## **Wolseley to Downtown Walk/Bike Project**

**Bike Winnipeg Comments and Recommendations Regarding Preliminary Design – June 2019**

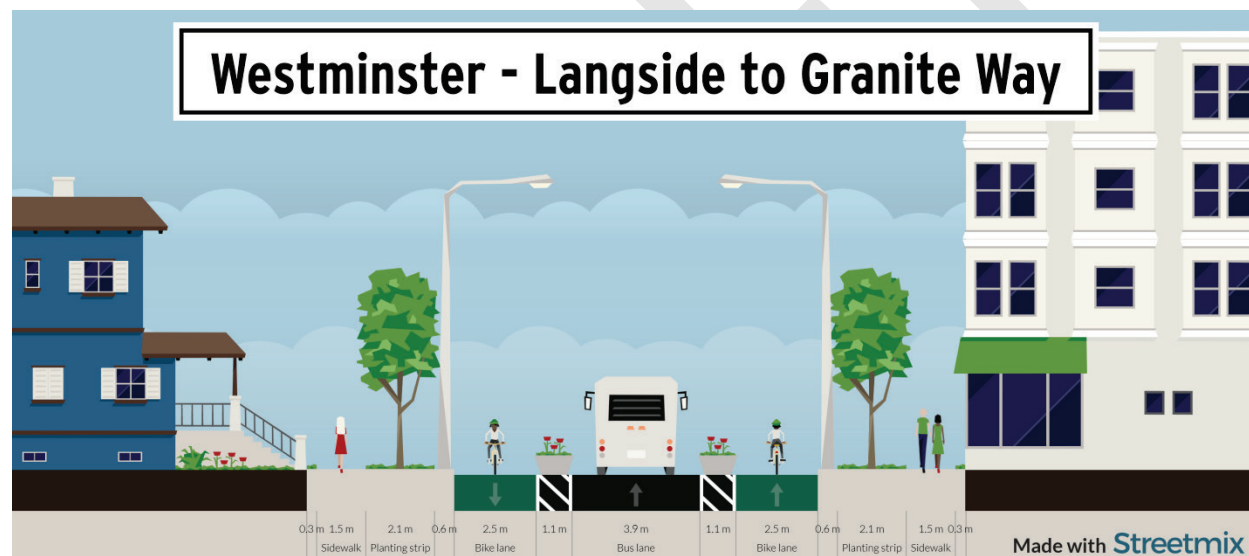
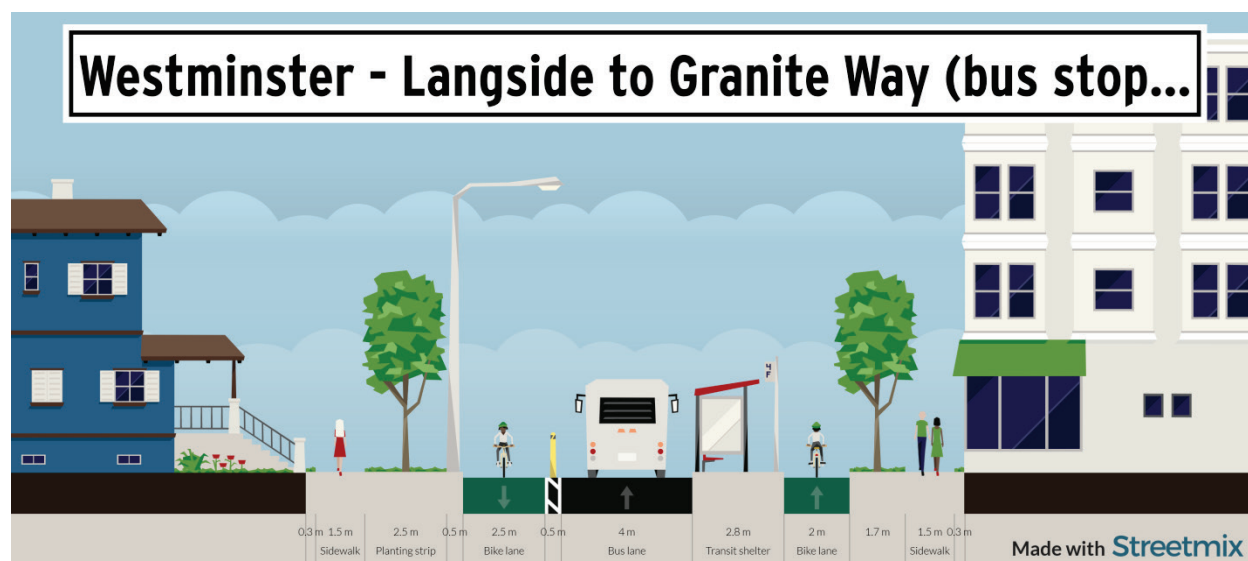
It should be noted that people already choose not to detour along the river pathway south of Assiniboine Avenue between Osborne and Edmonton. It's unlikely that a detour south of the curling club will be treated any differently.

For these reasons, we recommend against any option to divert people on bikes south of the curling club. The on road options, including the addition of short two-way segments described above provide better options.

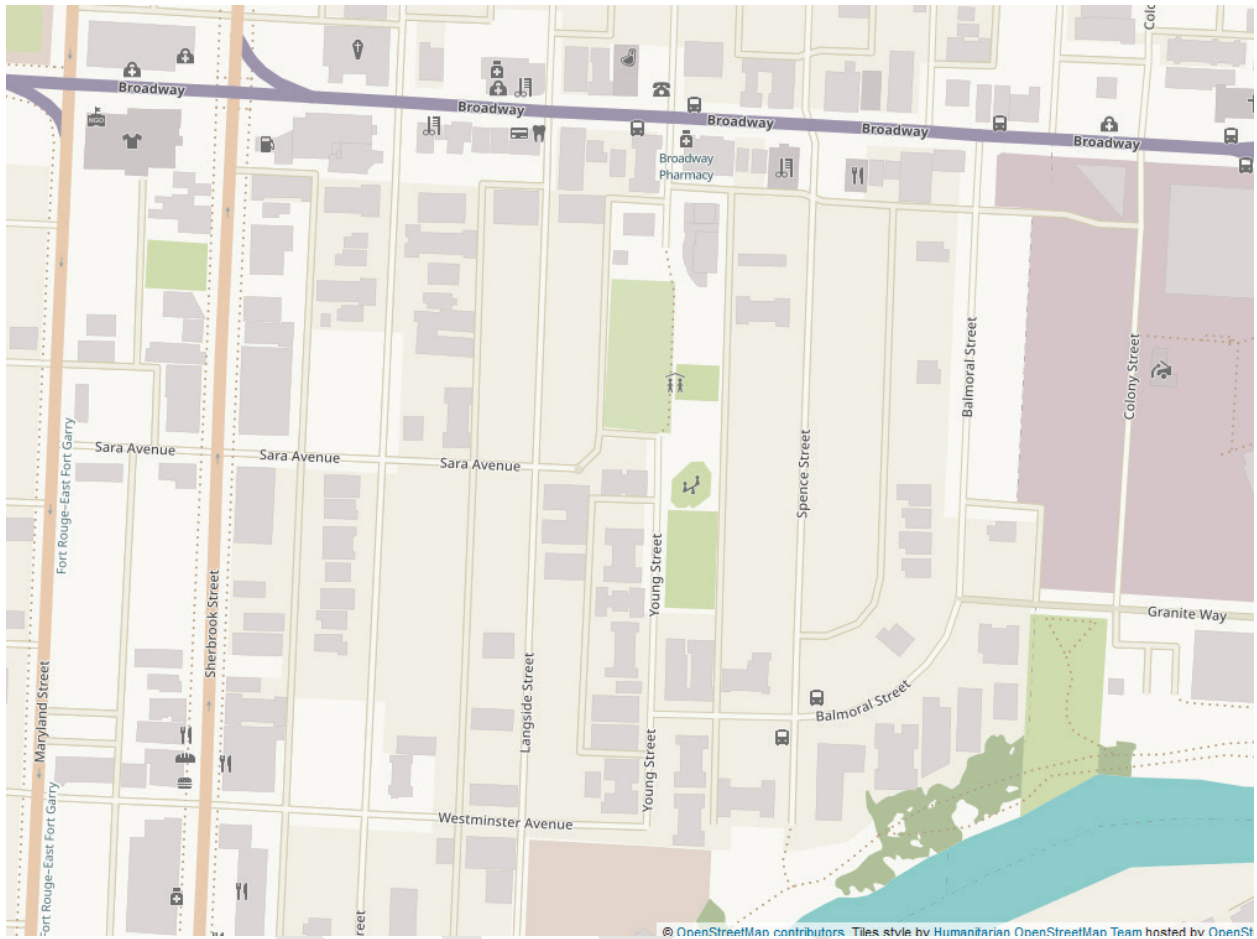
We like the decision to convert the Westminster/Young/Balmoral corridor to one-way northbound traffic as the only option provided that we feel adequately meets the demands to improve safety, connectivity, and cycling comfort.

This is the only option that approaches the widths recommended by best practice, but it also meets neighbourhood goals of reducing cut-through traffic, improving safety, improving bicycle network connectivity, and increasing the comfort level of folks on bikes.

In contrast to the comfort levels provided to road users in option 1 with its conversion of Westminster/Young/Balmoral to a one-way, options 2 and 3 provide bike lanes that will be narrow to meet TAC guidelines or to permit passing. IN the case of option 3, people on bike would be provided with nothing more than painted bike lanes to improve their safety and comfort. These options fall far below the expectations and desires set out in both the West Broadway Community Plan 2016-2021 and the Phase I Public Engagement report.

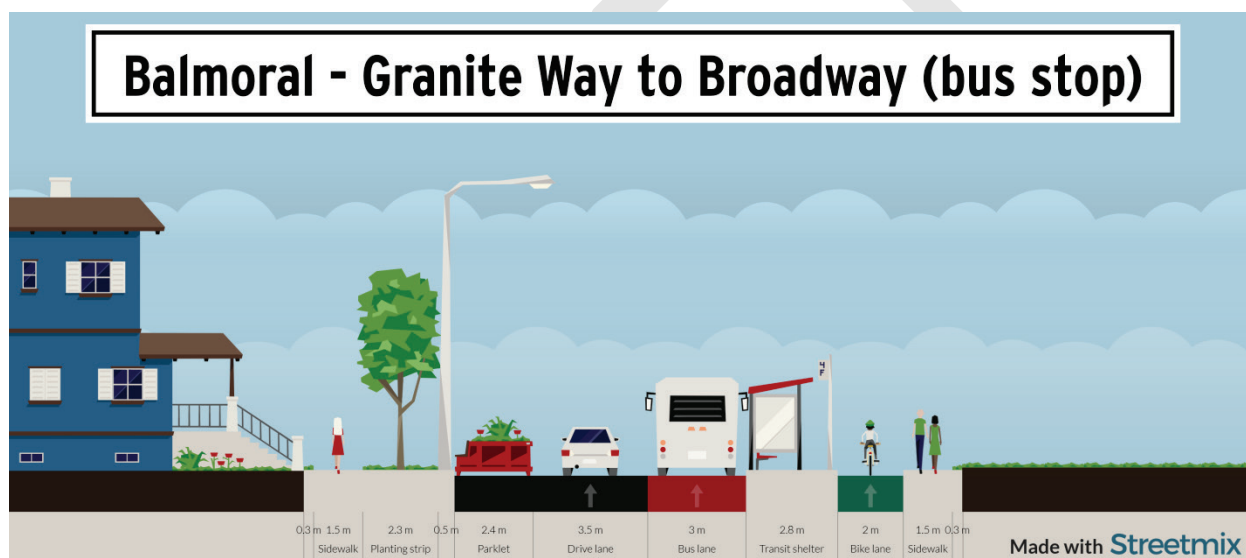
To reach Langside from Young, it might be possible to install a one-way cycle track between an off-peak parking lane and sidewalk on the south side of Portage. This would provide a cycle track that was parking protected in off-peak hours, but next to a diamond lane during peak hours. There are no bus stops on this section of eastbound Portage.

To facilitate westbound people on bike, it may be possible to remove the left turn lane on Portage between Langside and Young to provide a one-way cycle track in the Portage median between Young and Langside. This option may be a hard sell as the left turn off Portage onto NB Young is the access route to parking.

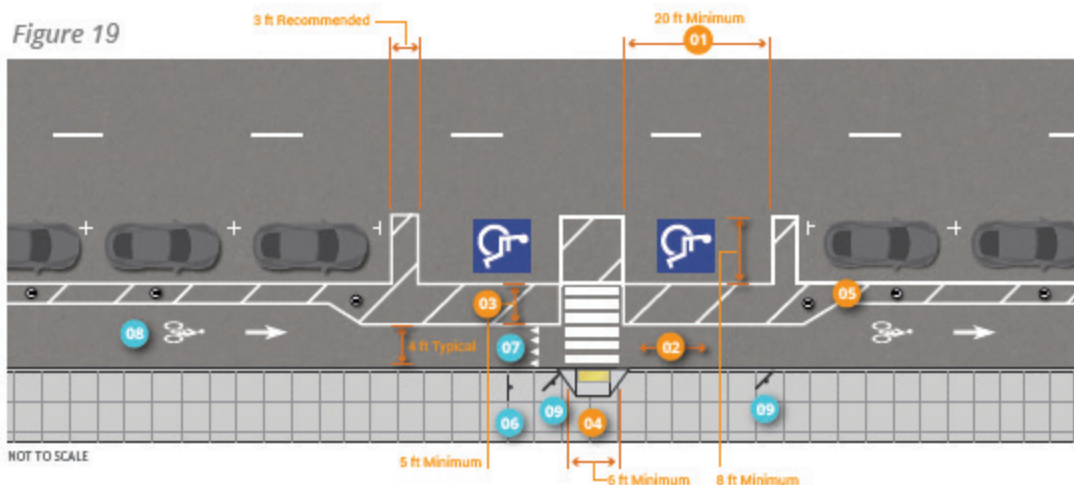
- ~ 24m right of way.
- ~ 14m curb to curb between Sherbrook and Maryland.
- South Boulevard
  - Boulevard is about 4'3" (1.3m) sidewalk to curb (including curb)
  - Sidewalk is about 5' (1.5m)
  - South side includes about 14' (4.25m) space between building and sidewalk
- North side boulevard
  - Boulevard is about 47" (1.2m) from curb to sidewalk (including curb)

- Sidewalk is about 5' (1.5m)

There are needed bus stops on both sides of Wolseley between Sherbrook and Maryland – they are both far side bus stops.

- Two one way protected bike lanes between Sherbrook and Maryland
- Requires removal of one parking lane, but only one or two spots are available on the north side anyway.
- Push bus stop as far east as possible and bend roadway to allow for a left hand turn land and bike box at Maryland.

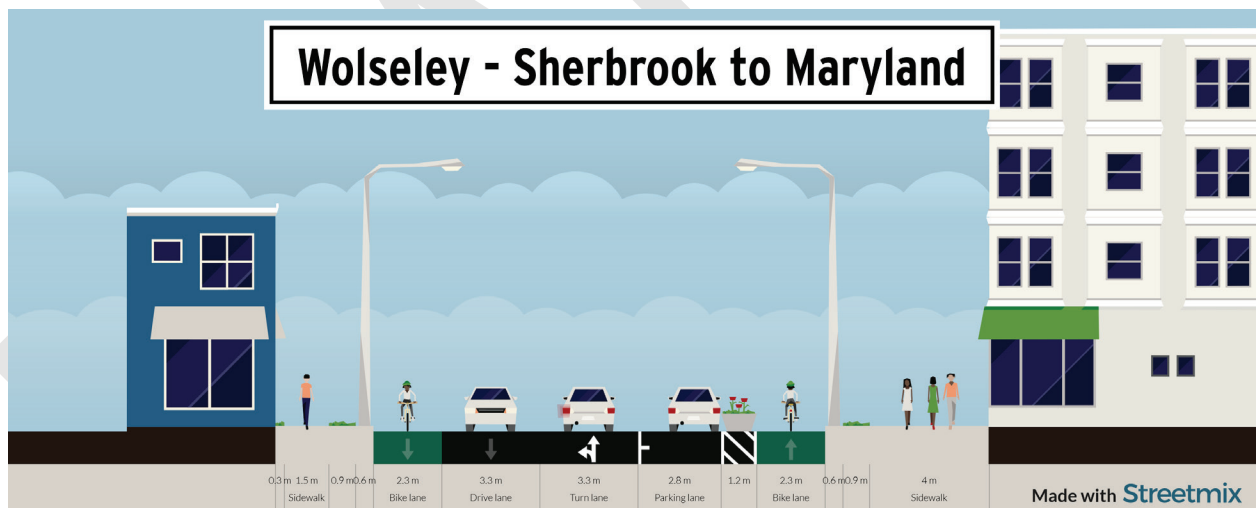
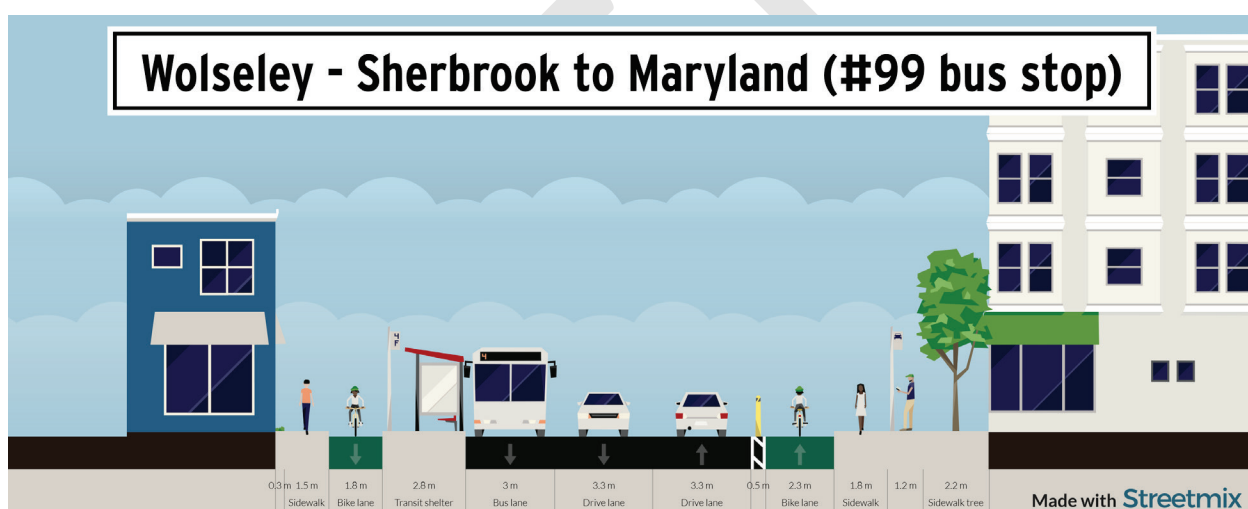
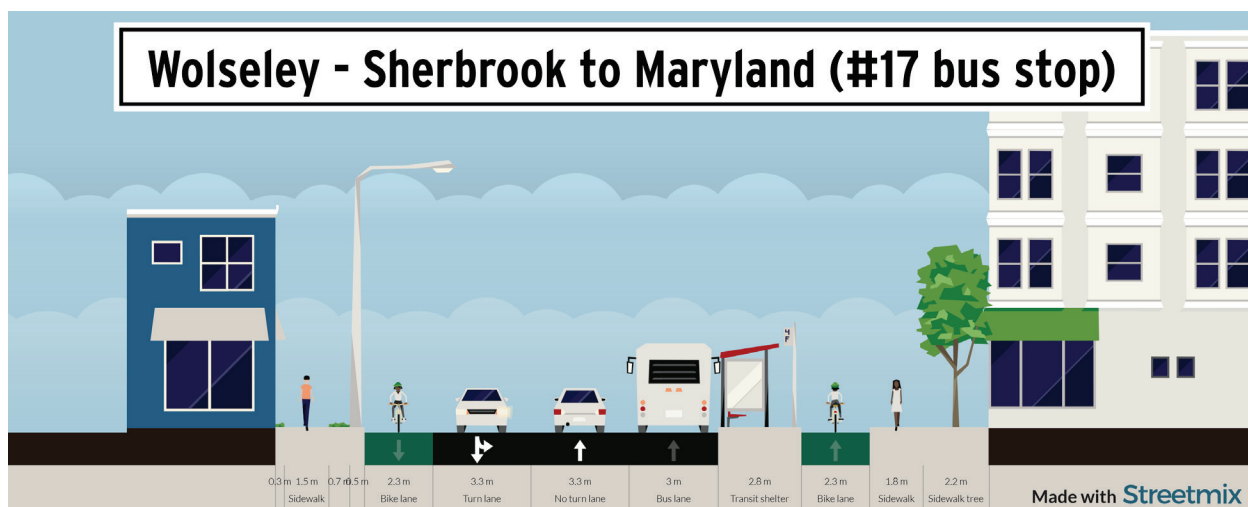
Removing one lane may provide space to install protected bike lanes, leave room for transit, and maintain some parking/drop off zones for the hospital.

A bike box at Wolseley and Maryland might be desirable to help facilitate left turns off of westbound Wolseley onto southbound Maryland by people on bike. It could be hard to find space on Wolseley for a two stage left turn (a person on bike would have to cross the sidewalk to wait for a green light on Maryland and then again to reach the southbound bike lane on Maryland). Combined with traffic volume reductions this might be acceptable.

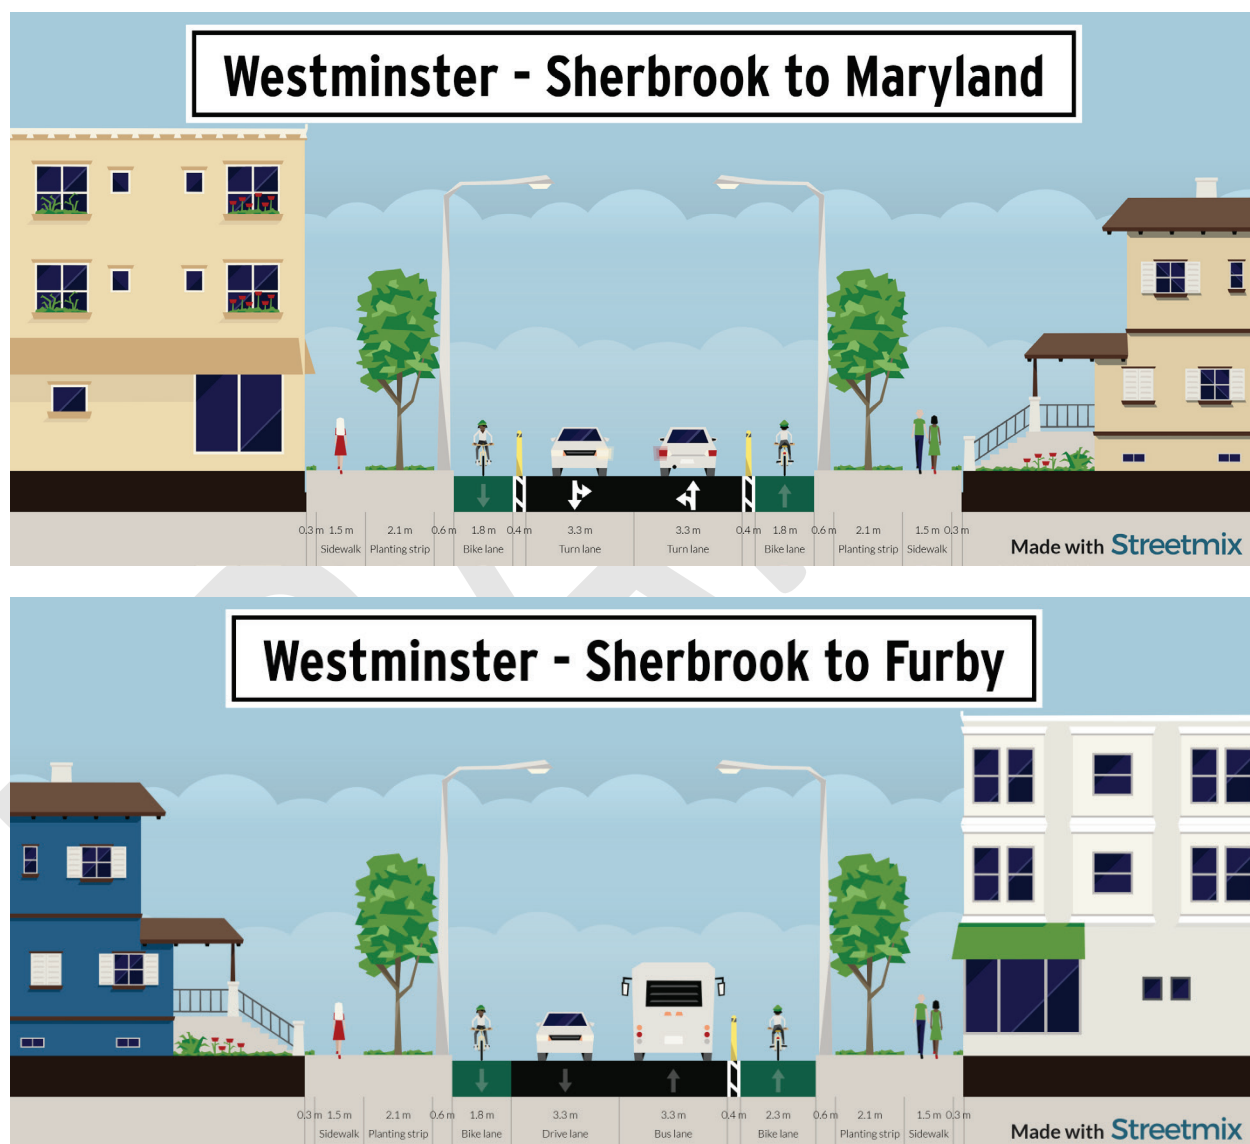
- 20.1 m right of way
- 11m roadway – curb to curb
- North Side Boulevard
  - 2.7m boulevard – curb to sidewalk (including curb)
  - Boulevard has mature trees
  - 1.5m sidewalk
  - 0.3m setback
- South Side Boulevard
  - 2.7m boulevard – curb to sidewalk (including curb)
  - Boulevard has mature trees
  - 1.5m sidewalk
  - 0.3m setback

Parking would need to be prohibited to provide any bike lane (protected or not) on Westminster if two-way traffic is to be retained. Even then, only a narrower bike lane can be provided, likely 2.2m or less in width including any buffer/gutter. This constraint is true for the section of Westminster between Arlington and Maryland all the way through to Langside, where East Option 1 proposes turning Westminster into an eastbound one-way, which would free up space for protected bike lanes (see above for the benefits of this option and potential cross sections made possible by the conversion to a one-way).

Since the narrower conditions along Westminster exist all the way to Arlington, we think that its worth reducing the quality of the westbound bike lane from a protected bike lane to an at-grade

Where width exists, we would recommend raised bike lanes along Westminster as the best compromise between width and protection along the constrained sections of Westminster.
